Update Project Proposal: SFF-TA-1016 Internal Unshielded High Speed Connector System

Presented: 2025-10-03

- Modification proposals
  - Add wording to clarify the plug card type
  - Add two more latch holes in receptacle connector and modify plug latch
  - Reduce signal gold finger length
- Editor(s): Zhineng Fan
- Supporters: Minimum 3 member companies required (can include editor's company)
  1. Amphenol
  2. FIT
  3. Intel
  4. Lotes
  5. TE Connectivity

- Update to 38P/74P receptacle

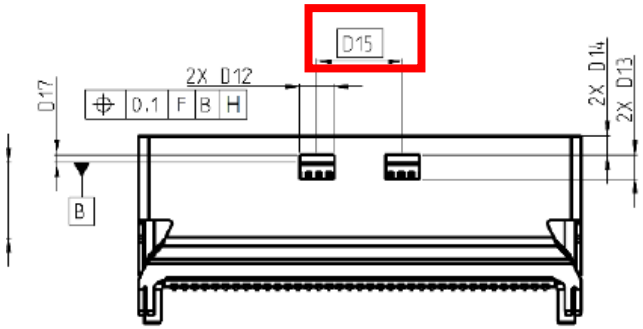
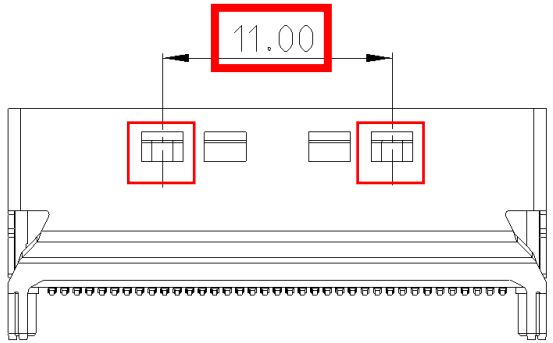
Add Receptacle Latch Holes

Designator	Description	Dimension (mm)	Tolerance
A15	Latch Slot Spacing	5.00	Basic
B15	Latch Slot Spacing	5.00	Basic
C15	Latch Slot Spacing	5.00	Basic
D15	Latch Slot Spacing	5.00	Basic

Designator	Description	Dimension (mm)	Tolerance
A15	Inner latch Slot Spacing	5.00	Basic
A31	Outer latch Slot Spacing	11.00	Basic
B15	Inner latch Slot Spacing	5.00	Basic
B32	Outer latch Slot Spacing	11.00	Basic
C15	Inner latch Slot Spacing	5.00	Basic
C31	Outer latch Slot Spacing	11.00	Basic
D15	Inner latch Slot Spacing	5.00	Basic
D32	Outer latch Slot Spacing	11.00	Basic

- Update to 124P/148P receptacle

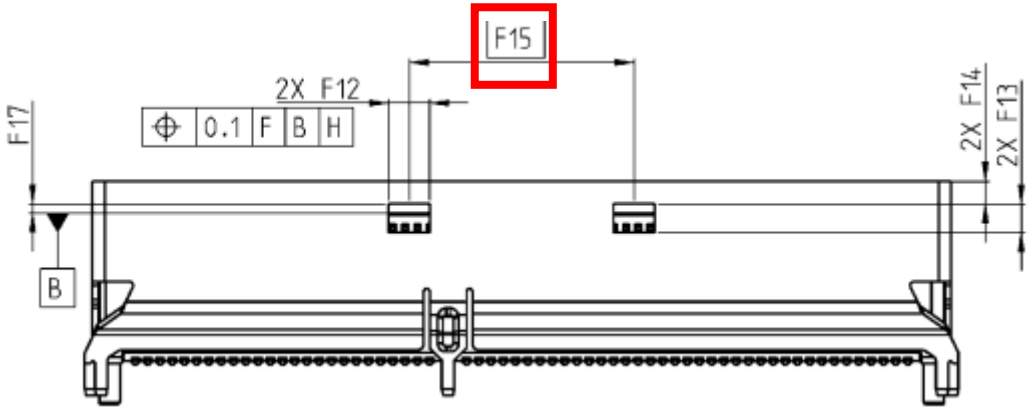
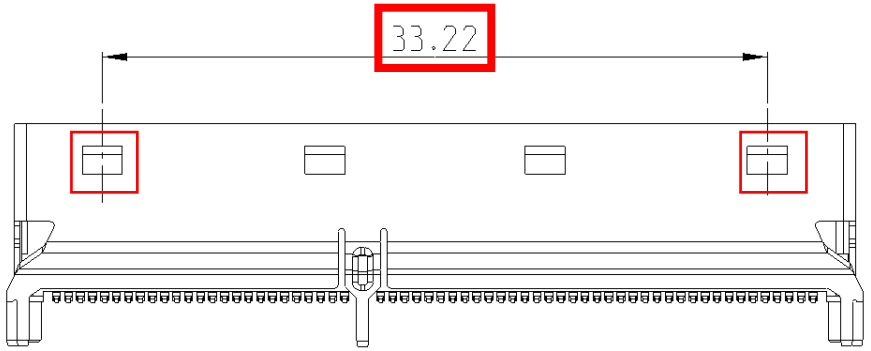
Add Receptacle Latch Holes

Designator	Description	Dimension (mm)	Tolerance
E15	Latch Slot Spacing	11.00	Basic
F15	Latch Slot Spacing	11.00	Basic
G15	Latch Slot Spacing	11.00	Basic
H15	Latch Slot Spacing	11.00	Basic

Designator	Description	Dimension (mm)	Tolerance
E15	Inner latch Slot Spacing	11.00	Basic
E32	Outer latch Slot Spacing	33.22	Basic
F15	Inner latch Slot Spacing	11.00	Basic
F35	Outer latch Slot Spacing	33.22	Basic
G15	Inner latch Slot Spacing	11.00	Basic
G32	Outer latch Slot Spacing	33.22	Basic
H15	Inner latch Slot Spacing	11.00	Basic
H35	Outer latch Slot Spacing	33.22	Basic

- Modify 38P/74P plug

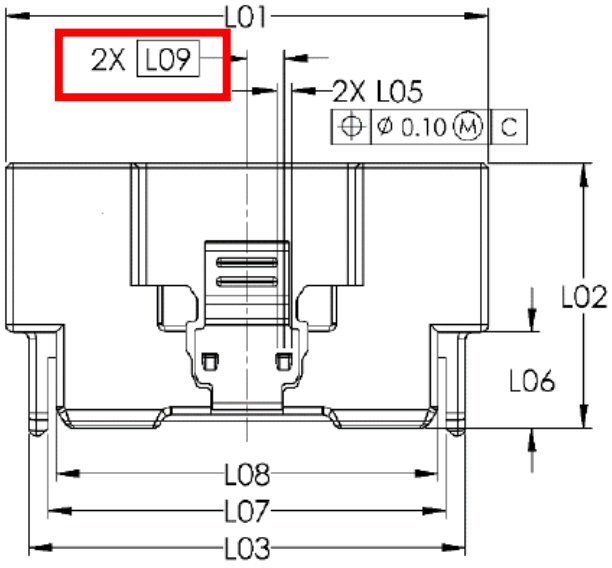
Modify Plug Latch Distance

Designator	Description	Dimension (mm)	Tolerance
J09	Datum C (Interface Centerline) to Latch Tab Center	2.42	Basic
L09	Datum C (Interface Centerline) to Latch Tab Center	2.42	Basic

Designator	Description	Dimension (mm)	Tolerance
J09	Datum C (Interface Centerline) to Latch Tab Center	5.50	Basic
L09	Datum C (Interface Centerline) to Latch Tab Center	5.50	Basic

- Modify 124P/148P plug

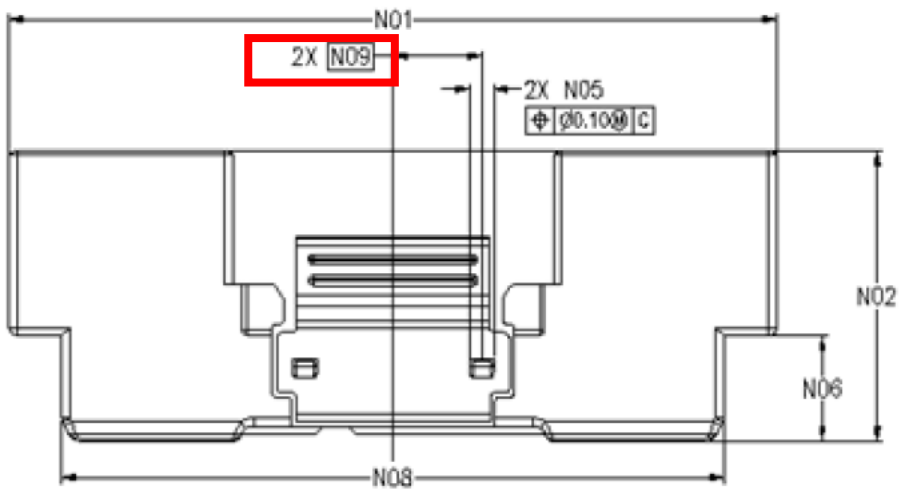
Modify Plug Latch Distance

Designator	Description	Dimension (mm)	Tolerance
N09	Datum C (Interface Centerline) to Latch Tab Center	5.50	Basic
Q09	Datum C (Interface Centerline) to Latch Tab Center	5.50	Basic

Designator	Description	Dimension (mm)	Tolerance
N09	Datum C (Interface Centerline) to Latch Tab Center	16.61	Basic
Q09	Datum C (Interface Centerline) to Latch Tab Center	16.61	Basic

- Modify signal gold finger length for all pin counts

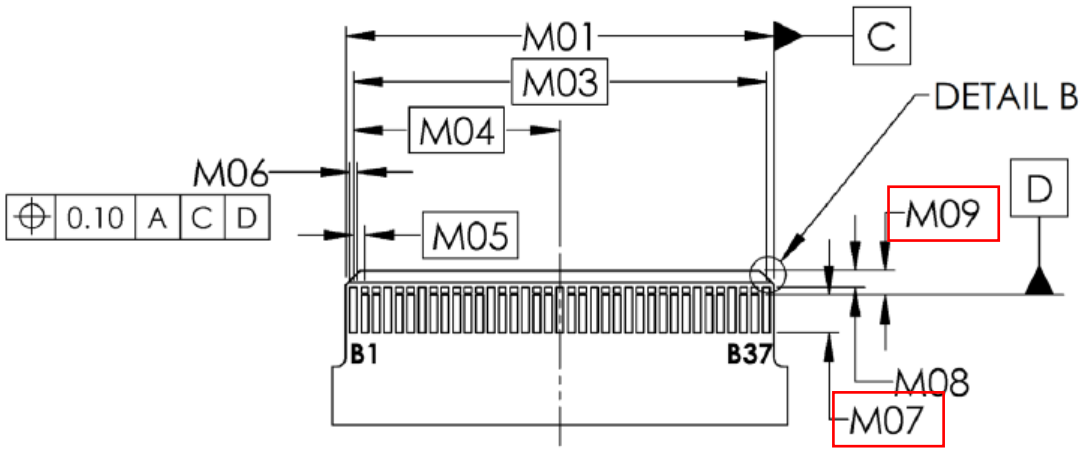
Modify Signal Gold Finger Length

Designator	Description	Dimension (mm)	Tolerance
K09	Second-mate Pad to Card Edge	1.28	+/-0.1
K07	Pad Length – Second-mate	1.97	MIN
M09	Second-mate Pad to Card Edge	1.28	+/-0.1
M07	Pad Length – Second-mate	1.97	MIN
P09	Second-mate Pad to Card Edge	1.28	+/-0.1
P07	Pad Length – Second-mate	1.97	MIN
R09	Second-mate Pad to Card Edge	1.28	+/-0.1
R07	Pad Length – Second-mate	1.97	MIN

Designator	Description	Dimension (mm)	Tolerance
K09	Second-mate Pad to Card Edge	1.58	+/-0.1
K07	Pad Length – Second-mate	1.67	MIN
M09	Second-mate Pad to Card Edge	1.58	+/-0.1
M07	Pad Length – Second-mate	1.67	MIN
P09	Second-mate Pad to Card Edge	1.58	+/-0.1
P07	Pad Length – Second-mate	1.67	MIN
R09	Second-mate Pad to Card Edge	1.58	+/-0.1
R07	Pad Length – Second-mate	1.67	MIN
